PCN / EOL Notification

Product Change Notification Number: RC103802

Title: AT91SAM7S64 MRLB Revision, Ordering Code and Manufacturing Location Change

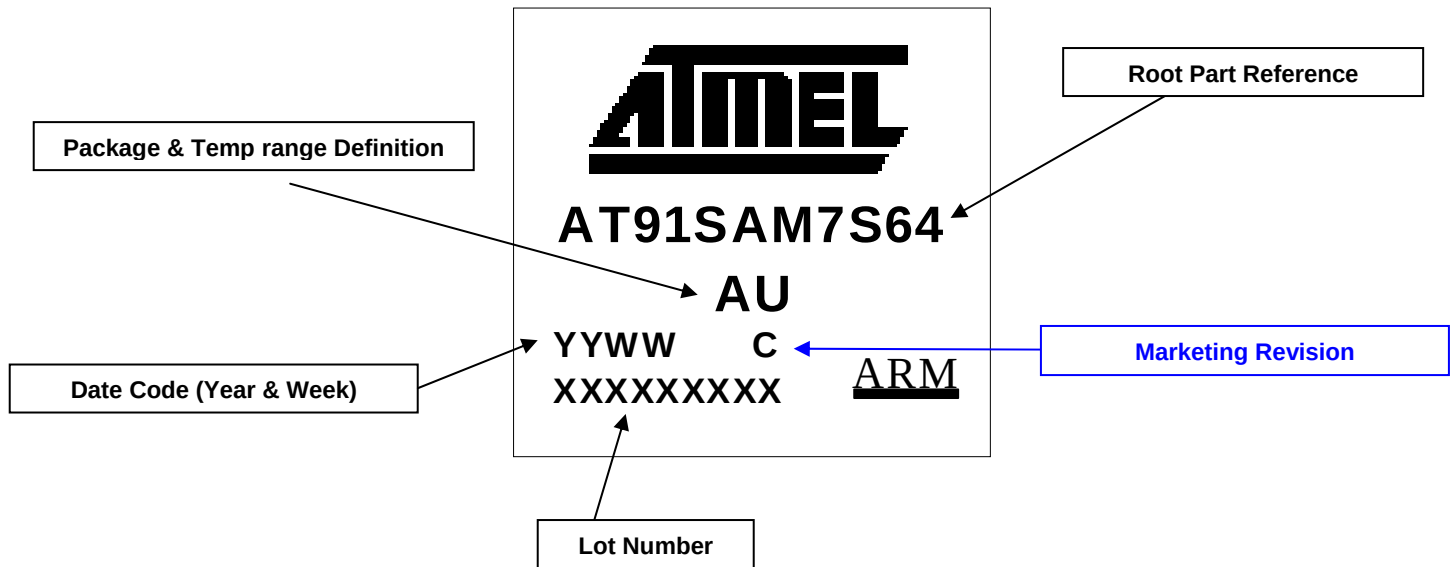
Marketing Revision on the topside marking will be incremented from B to **C**.

Chip-ID: AT91SAM7S64 Revision C chip ID is: 0x27090544

Top side marking:**Qualification Data:**☒ available☐ will be available in WW__☐ not applicable**Samples:**☐ available☒ will be available in Nov. 12, 2010☐ not applicable**Quantifiable Impact on Quality & Reliability:**
